ALAMEDA COUNTY  
HEALTH CARE SERVICES

Subject: Fuel Leak Case No. RO0000092 and Geotracker Global ID T0600100065, American Brass & Iron Foundry, 7825 San Leandro Street, Oakland, CA 94621

Alameda County Environmental Health (ACEH) staff has reviewed the fuel leak case file for the above-referenced site including the recently submitted document entitled, "Site Investigation Work Plan," dated July 9, 2007 and prepared on your behalf by The Source Group, Inc. The Site Investigation Work Plan proposes soil gas sampling, soil borings, and grab groundwater sampling to define the extent of contamination from former USTs at the site. We request that you submit a revised Work Plan that addresses the technical comments below and includes more detailed maps of each of the UST areas where additional investigation is proposed.

# 550 Gallon Gasolin UST

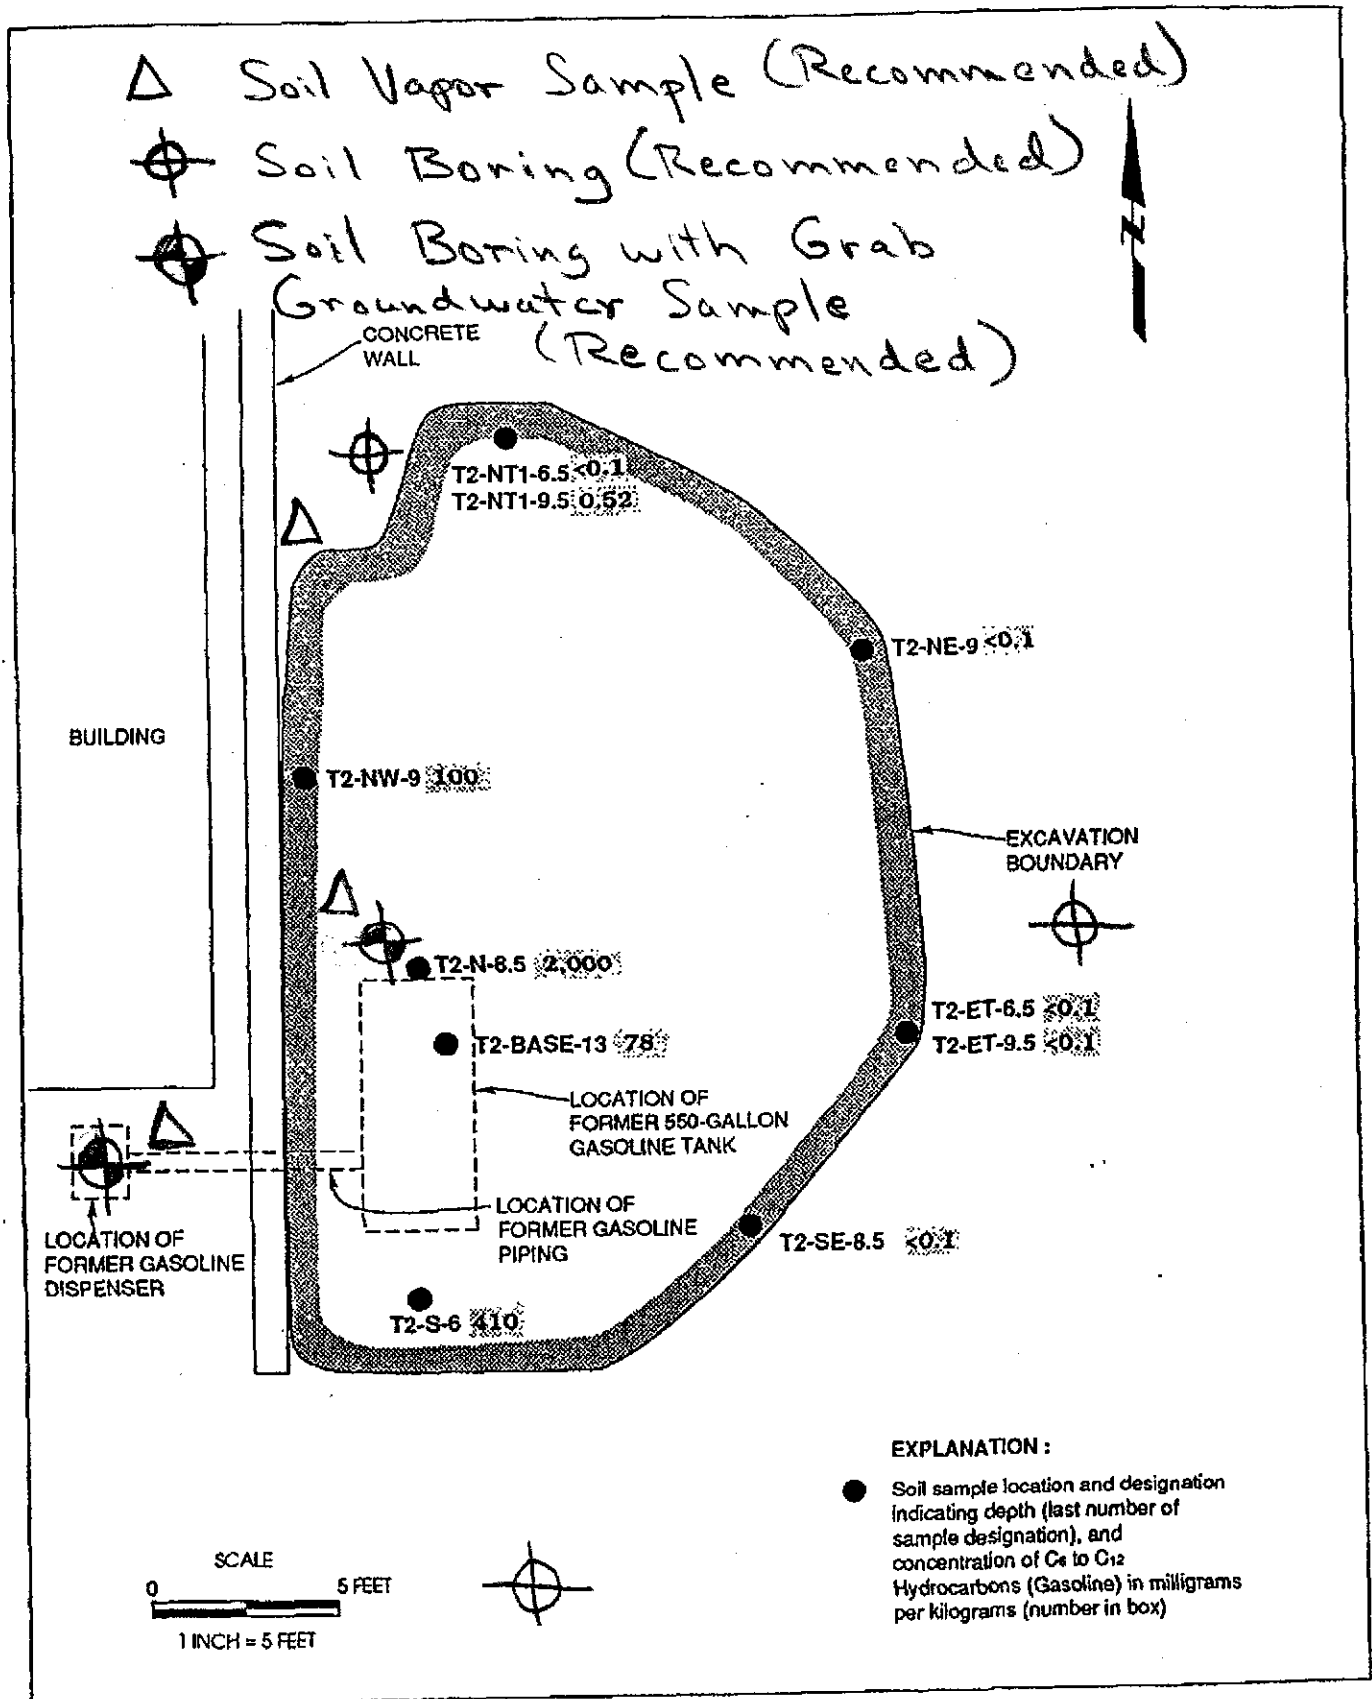
2. **Former 550-Gallon Gasoline UST.** The Site Investigation Work Plan proposes advancing five soil borings and collecting three soil gas samples and two grab groundwater samples in the area of the former 550-gallon gasoline UST. Based on review of the report entitled, "Report on Removal of 550-Gallon Capacity Underground Gasoline Storage Tank," dated January 31, 1992, excavation of gasoline-contaminated soil was terminated to the west to avoid potential structural damage to the adjacent building and concrete wall. Excavation was also terminated to the south to allow vehicle traffic to continue during the tank removal. No excavation or sampling appears to have taken place near the former gasoline dispenser, which was west of the concrete wall (see attached Former 550-Gallon Gasoline UST figure). We request that you submit a Revised Work Plan that includes a more detailed map with proposed sampling locations in the area of the former 550-gallon UST. Recommended soil vapor, soil, and grab groundwater sampling locations are also shown on the attached Former

550-Gallon Gasoline UST figure. We request that the central boring within the tank excavation be extended to a minimum depth of 30 feet bgs in order to define the vertical extent of contamination. The central boring is to be extended greater than 30 feet bgs if staining, odor, or elevated PID readings are observed in the lower five feet of the boring. The remaining four soil borings located outside the former excavation are to be extended to a minimum depth of 15 feet bgs. Soil samples are to be collected continuously and logged in the field for soil type, color, moisture content, odor, and other observed features and screened with a photoionization detector. Soil samples are to be collected for laboratory analysis at any interval where visible staining, odor, or elevated PID readings are observed. If visible staining, odor, or elevated PID readings are observed, a sufficient number of soil samples must be collected to characterize the vertical interval over which the contamination occurs. If no visible soil staining, odor, or elevated PID readings are observed in the soil boring, we request that a minimum of four soil samples be collected for laboratory analyses from each soil boring. The Work Plan currently proposes the collection of soil samples for chemical analyses from depths of 0.5, 2.0, and 5.0 feet bgs and at lithologic changes. We note that the fixed depth intervals of 0.5, 2.0, and 5.0 feet bgs are above the depth of the former UST. We have no objection to collecting soil samples for chemical analyses at these depth intervals in the area of the former gasoline dispenser and to help characterize the shallow fill. However, chemical analyses of deeper soil samples will be required to characterize soil contamination from the former UST. We request that you present a table of proposed soil samples for chemical analyses in the Revised Work Plan requested below. Within the central soil boring, depth-discrete grab groundwater samples are to be collected from first encountered groundwater and all significant water-bearing layers below 15 feet bgs to define the vertical extent of groundwater contamination.

# 10,000-Gallon Diesel UST

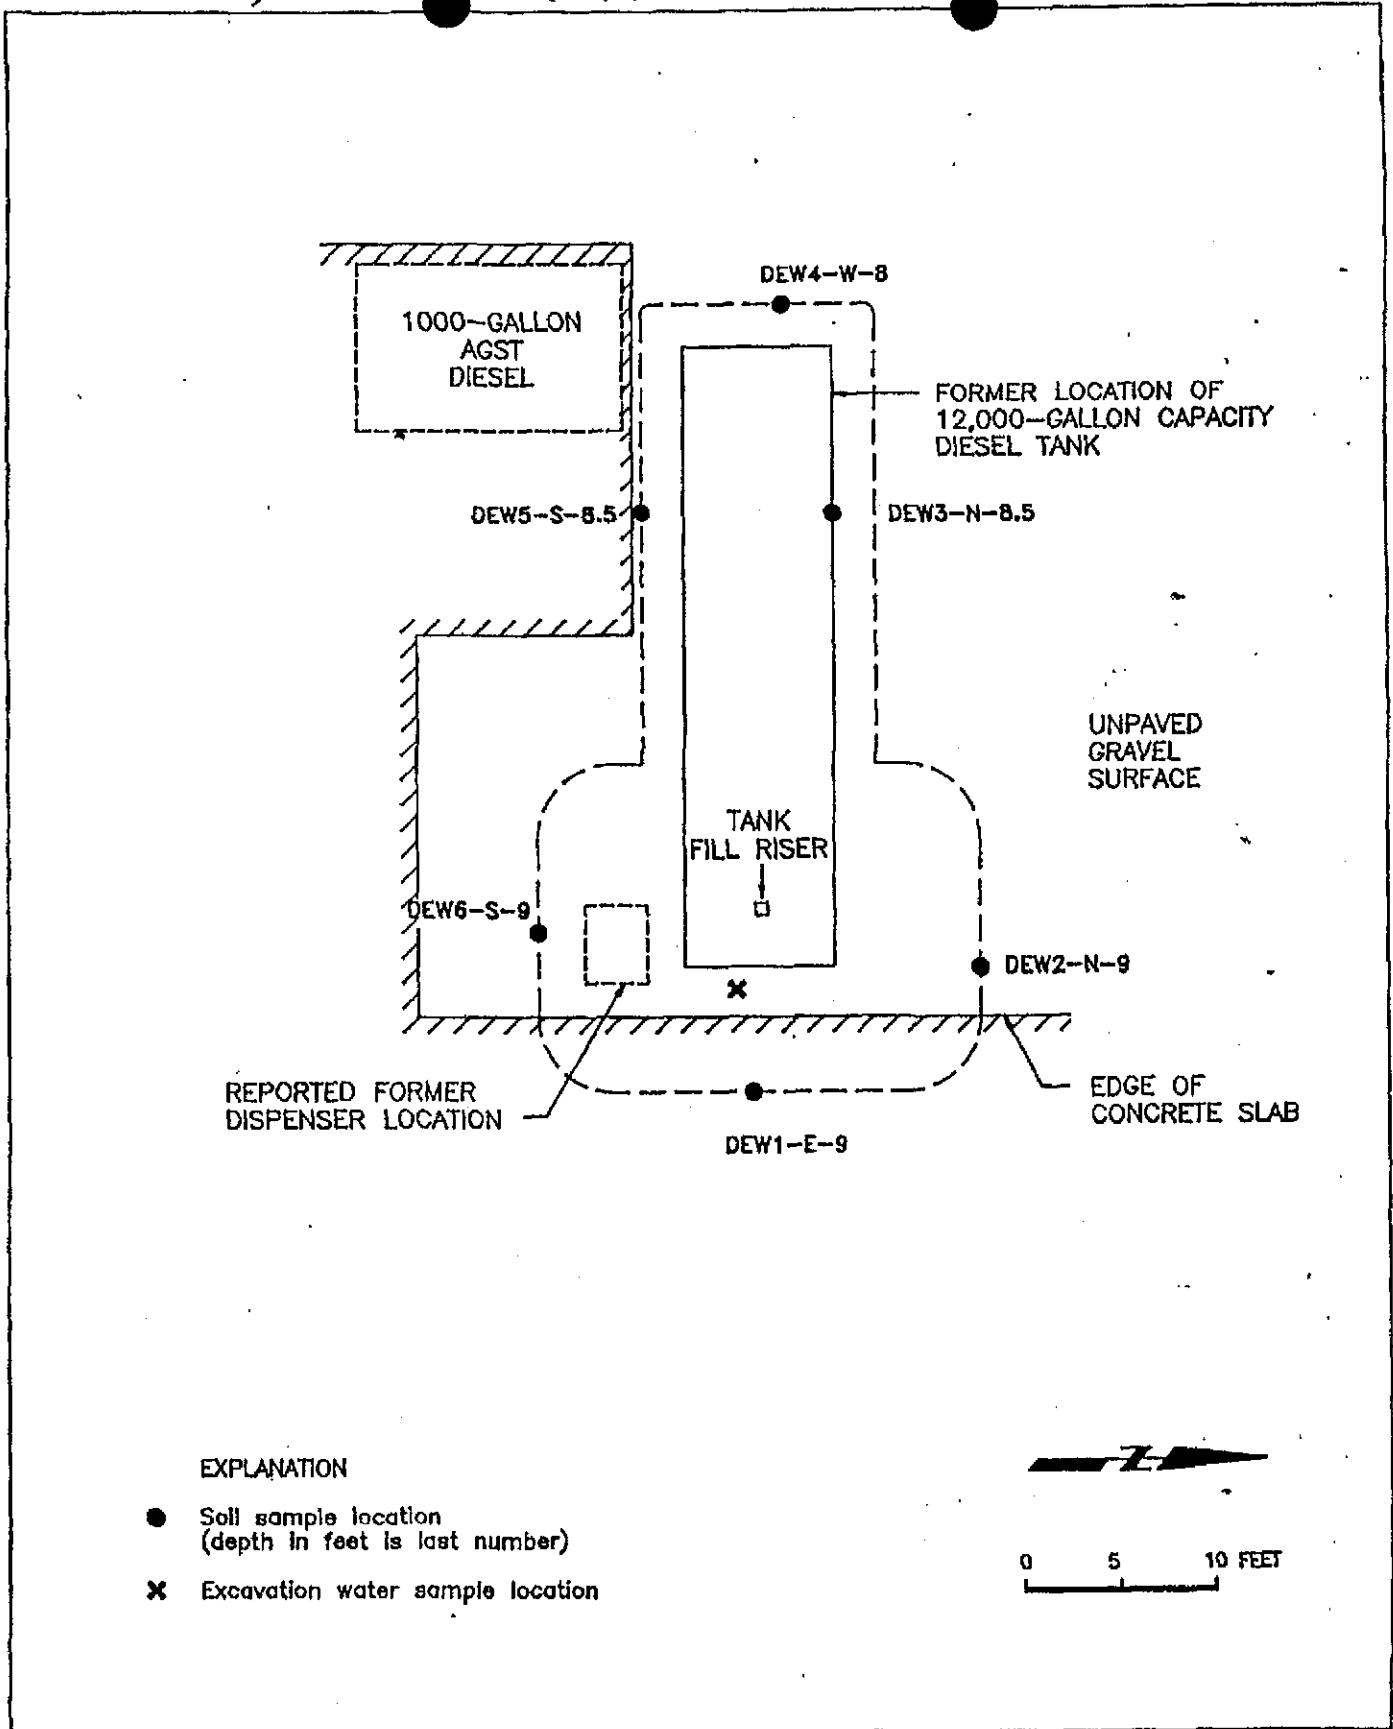
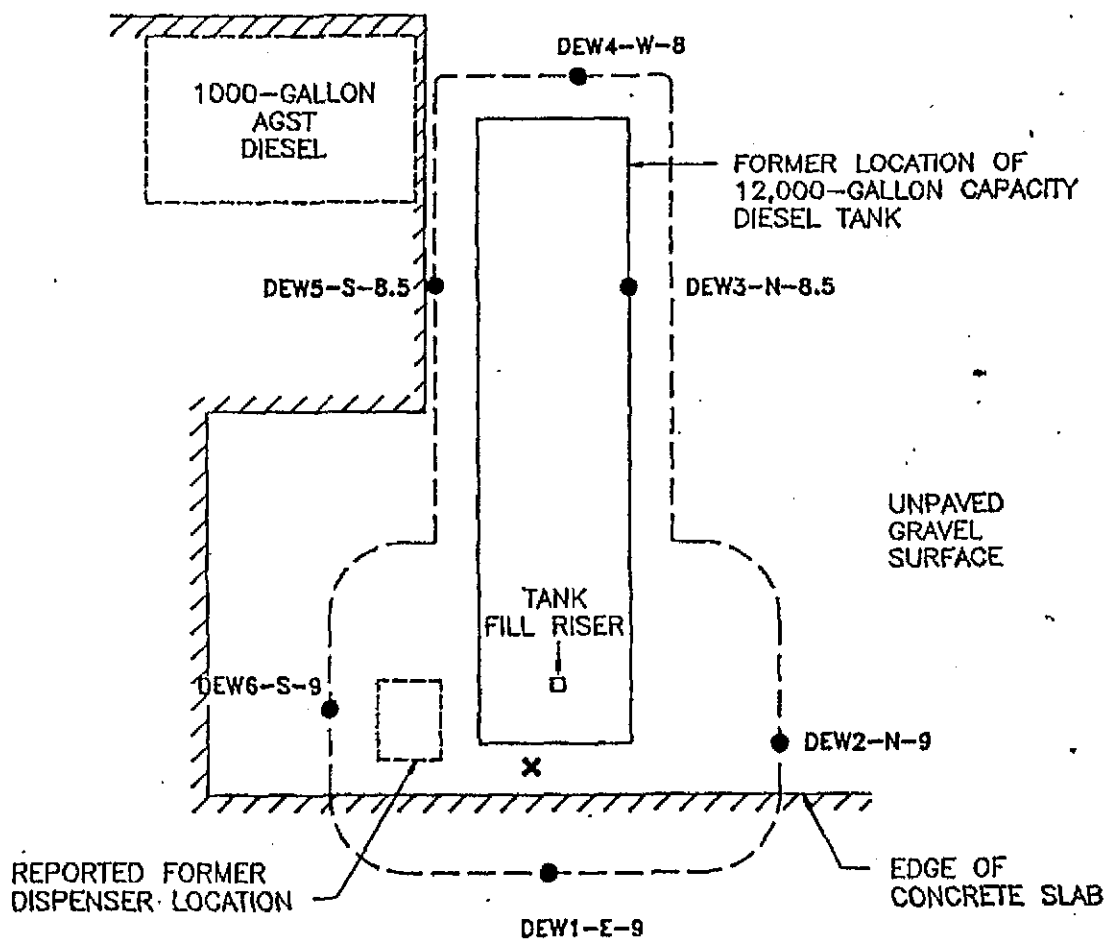
5. **Former 10,000-Gallon Diesel UST (Also Referred to as 12,000-Gallon Diesel UST).** Further investigation is required in the area of the former 10,000-gallon diesel UST and monitoring well MW-7. The boring log for well MW-7 indicates that a strong hydrocarbon odor was observed between approximately 7 and 10 feet bgs and a faint odor was observed below 14 feet bgs. Well MW-7 is approximately 60 feet north of the former 10,000-gallon diesel UST. A groundwater sample collected from well MW-7 in 2006 contained 520 µg/L of TPH as diesel. We request that you conduct further investigation to assess whether soil and groundwater in the area of the former 10,000-gallon diesel UST is the source of a hydrocarbon plume extending to well MW-7. Please present your plans in the Revised Site Investigation Work Plan requested below.
